MIL-PRF-83536/11
AMENDMENT 3
10 July 1999
SUPERSEDING
AMENDMENT 2
30 Sep 1996

PERFORMANCE SPECIFICATION SHEET

RELAYS, ELECTROMAGNETIC, ESTABLISHED RELIABILITY, DPDT,
LOW LEVEL TO 10 AMPERES, PERMANENT MAGNET DRIVE,
HERMETICALLY SEALED, ALL WELDED, AC COILS

SOCKET PIN

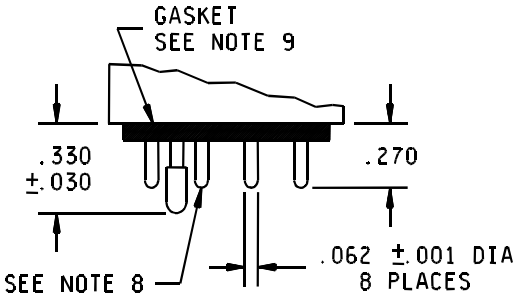
FIGURE 1, socket pin diagram, delete and substitute:
